# Access Compliance Report

## Public Rights-of-Way

Intersection ID: 25474	Main Street: MCMULLEN_CREEK_PY	Cross Street: JOHNSTON_RD	Location: N
ADA ID: 761C567699A0	Ramp Type: PerpDiag	Initial Pass/Fail: Fail	Overall Compliance: No
			Severity Score: 13.75

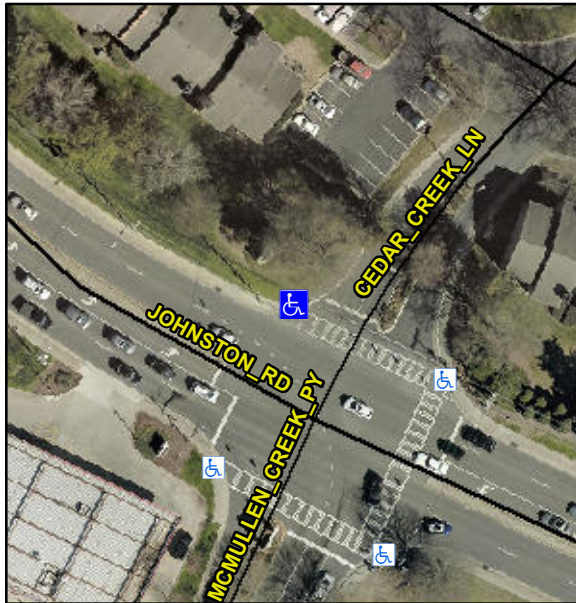
**Not Found, R304.2.2, R304.5.3**

Compliance	Description	Data	Compliance	Description	Data
N/A	Ramp Length (in)	60.0	No	Ramp Slope (%)	8.7
Yes	Ramp Width (in)	48.0	No	Ramp XSlope (%)	4.0
N/A	Flare Type LT	N/A	N/A	Flare Type RT	N/A
N/A	Flare Slope LT (%)	N/A	N/A	Flare Slope RT (%)	N/A
N/A	Flare Traversable LT?	N/A	N/A	Flare Traversable RT?	N/A
N/A	Landing Length (in)	N/A	N/A	DWS Provided?	N/A
N/A	Landing Width (in)	N/A	N/A	DWS Contrast?	N/A
N/A	Landing Slope (%)	N/A	N/A	DWS Length (in)	N/A
N/A	Landing X Slope (%)	N/A	N/A	DWS Full Width?	N/A
N/A	Landing Curb? (Y/N)	N/A	N/A	DWS Offset (in)	N/A
N/A	Shared Landing?	N/A			
N/A	Gutter Ponding?	N/A	N/A	Gutter Slope (%)	N/A
N/A	Gutter Lip Ht (in)	N/A	N/A	Gutter X Slope (%)	N/A
N/A	Painted X Walk1?	No	N/A	Painted X Walk2?	Yes
	X Walk 1 Direction	To SW		X Walk 2 Direction	To SE
N/A	X Walk 1 Width (in)	N/A	N/A	X Walk 2 Width (in)	105.0
	X Walk 1 Slope (%)	3.9		X Walk 2 Slope (%)	1.0
	X Walk 1 X Slope (%)	1.2		X Walk 2 X Slope (%)	2.6

**Remove & Replace Curb Ramp With Two New Directional Ramps or Equivalent.**
